A COMPANY OF THE SWATCH GROUP	Product Change Notification PCN	Nr. 180312-15 Publishing Date: March 21 st , 2018
---	--	--

Product information			
Item affected / Type	Tray for Holder SMTU2450N-LF		
Part - Nr. (SAP)	701118	Drawing-Nr.	n/a
Product Change Notification	Reason for proposed change	Description of change	
	☐ Customer requirement	Change of material of trays for SMTU2450N-LF holder China's first Environmental Protection Tax Law (EPT Law) comes into effect since 1st Jan. 2018. No foam trays are allowed to be produced anymore in China Therefore need to use different material for Foam Trays	
	☐ Quality complaint Nr.		
	☐ Quality improvement		
	☐ Process improvement –		
	☐ technical modification		
	☒ Normative requirements		
	☐ Cost efficiency		
	☐ Second source		
	☐ Correction of the documents		
	☐ Production location, change		
	☐ see attachment

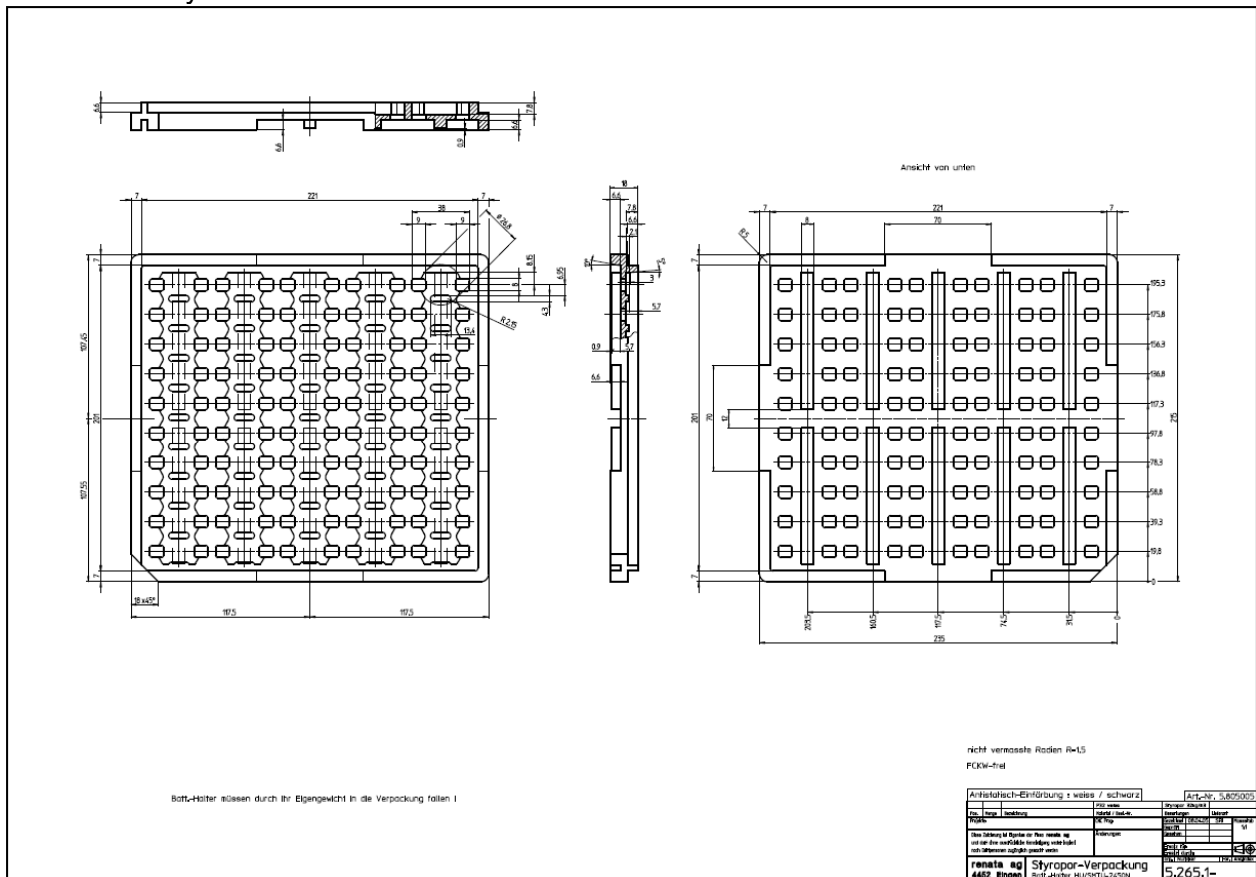
Product Change Notification	Description and reason of change
	Replacement of existing foam trays with PS (Polystyrene) material trays
	Drawing no. of Foam tray 5.265.1-
	Drawing no. of PS tray 5.439.2-
	Both drawing in attachment to compare.
	Same functions as PS tray
	Antistatic value
	Quantities per Tray and also per shrinked pack will be kept unchanged.
	Placing of holders within in tray will remain unchanged
	Height of unit packing will be different.
	Current height for unit package foam tray: 135.0mm
	Estimate height for unit package PS trays 131.0mm
	Manufacturer part number will remain unchanged Change will be controlled by Lot number.
	Rolling change expected. Rollout of old tray expected to start in June 2018
